2021.10 First Mass production inspection

Model Name: BFX-UA300

Document Version: ALT_STB_MP_CSMTINS_001

- Booting fail
 - Issue grade : Critical
 - Symptom : no boot after usb upgrade
 - Defect unit Q'ty : 1pcs / 756pcs
 - Defect rate : 0.13%

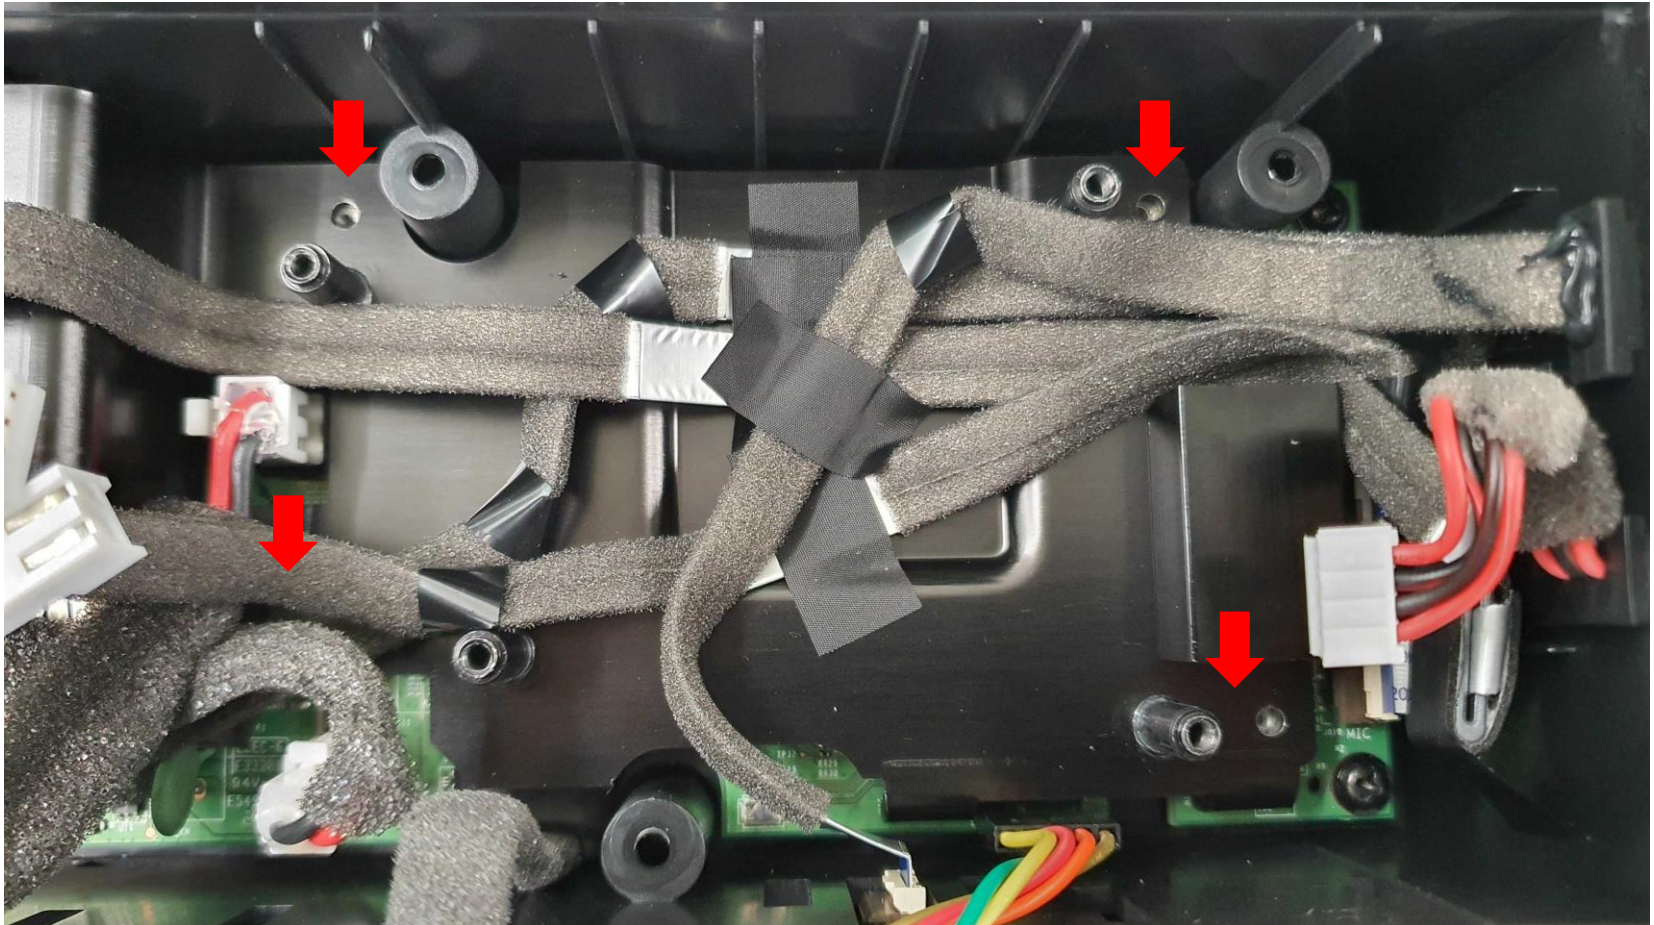
- ALT initial review
 - Booting is fail It may HW defect
 - No boot after SPI booting and eMMC update directly.
 - Booting log : [Link](#)
 - init cpupll 800MHz
 - init mempll 2400MHz
 - init 3GB DDR, lib version r63074
 - hw_init done
 - custom table done
 - asking BCM to load miniloader.
 - bcm_load_next_img error! init cpupll 800MHz
 - Also, this SET is no screw fastening inside
- Action item
 - FXN should be submit 8D report
 - Find the root cause.
 - Provide the preventive action

- FFC defect
 - Issue grade : Critical
 - Symptom : No turn on the LED, No button operation
 - Defect unit Q'ty : 2pcs / 756pcs
 - Defect rate : 0.26%

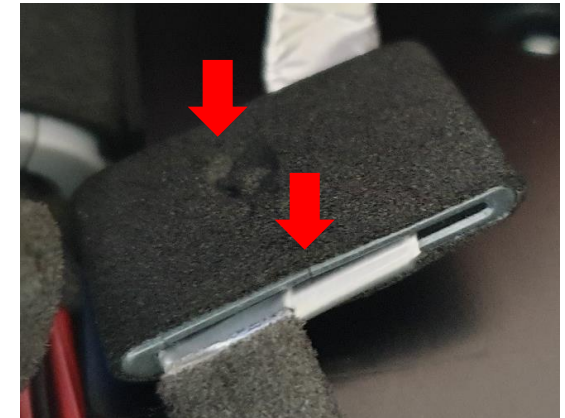
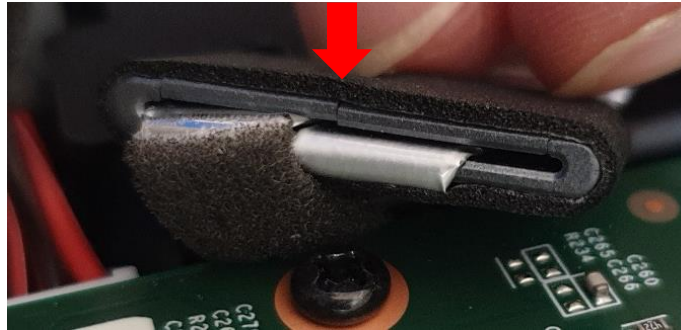
- ALT initial review
 - Checked all of connections -> No abnormalities found.
 - Changed FFC cable : Cleared Issue.
 - LED FFC : 14 Pin open
 - Button : 14, 15 Pin open
- Action item
 - FXN should be submit 8D report
 - Explain why it was not detected in the factory
 - Find the root cause.
 - Provide the preventive action
